Adopt Resolution certifying Mitigated Negative Declaration 15-09 and approve a Local Coastal Development Permit to remove five above-ground storage tanks and associated above-ground pipelines at 400 Studebaker Road. (District 3)

RE: Final (Revised) Workplan for Soil and Groundwater Sampling Post Removal of Five Aboveground Storage Tanks (ASTs) and Associated Piping [Adjacent] Alamitos Generating Station, 400 Studebaker Road, Long Beach, CA

RE: Revised Workplan for Soil and Groundwater Sampling Post Removal of Five Aboveground Storage Tanks (ASTs) and Associated Piping; Alamitos Generating Station, 400 Studebaker Road, Long Beach, CA

PROPOSED ABOVEGROUND STORAGE TANK SAMPLING LOCATIONS

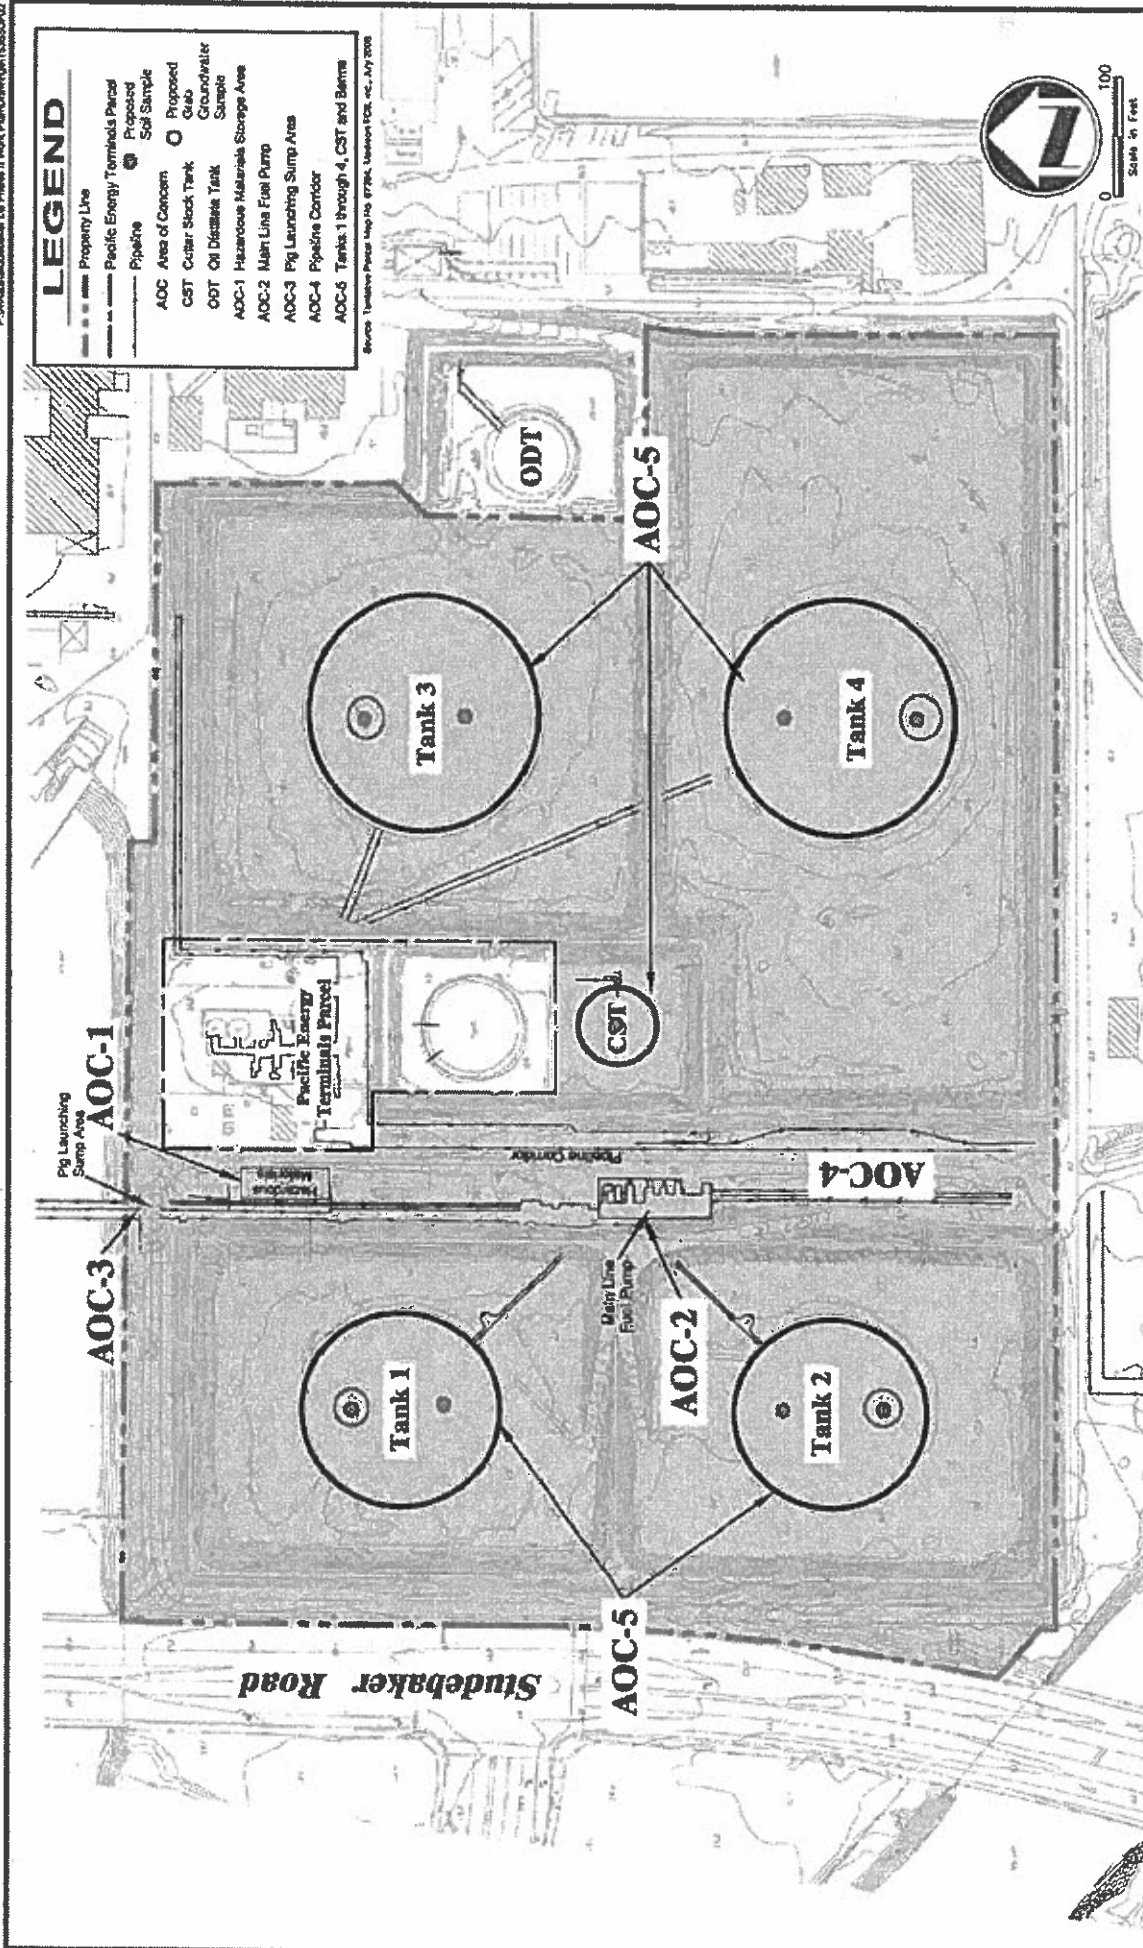
Page #2. Paragraph #2 There is a statement that refers to Figure 2. It states that there are no plans to remove, disturb or sample within AOC's 1 through 4 as shown on Figure 2. Isn't this where the work is shown to be done? AOC #5 are the 5 tanks, piping, and berms. Other AOCs are not going to be addressed at this time.

It is recommended that tank outlines on "figures" be darker to clearly show them as a reference point, should questions come up in the field. Hopefully, we are almost there. Please address these items and incorporate them into the next submittal. We will then review for the items specified above. Feel free to contact me with any questions. Have a GREAT Day.

Figure 2 has been changed.

Figure 6

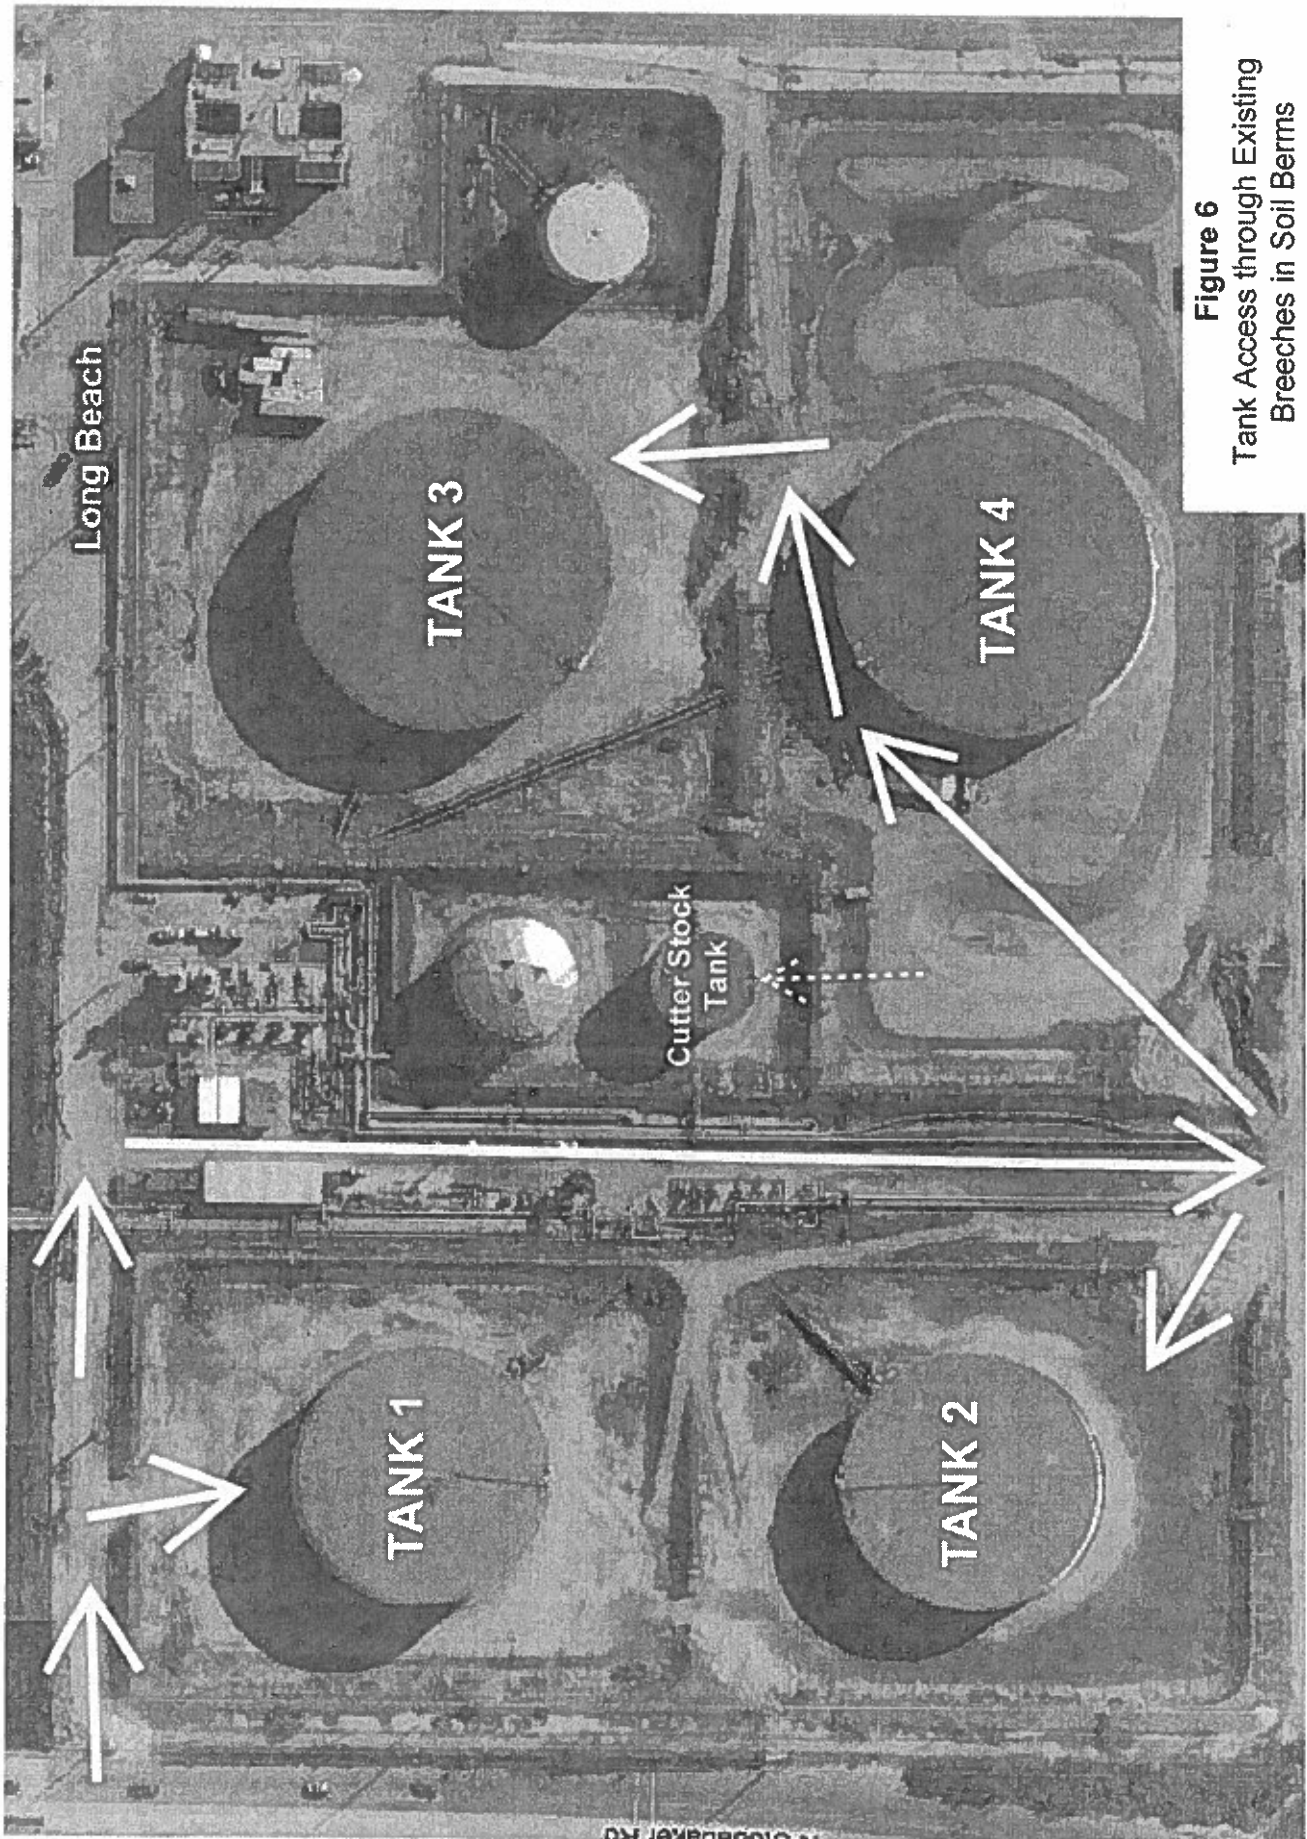
At this time, there is no plan to remove, disturb, or sample within AOCs 1 through 4 as shown on Figure 2. Access to the tanks that are to be removed will be performed via existing ramps as shown on Figure 6.
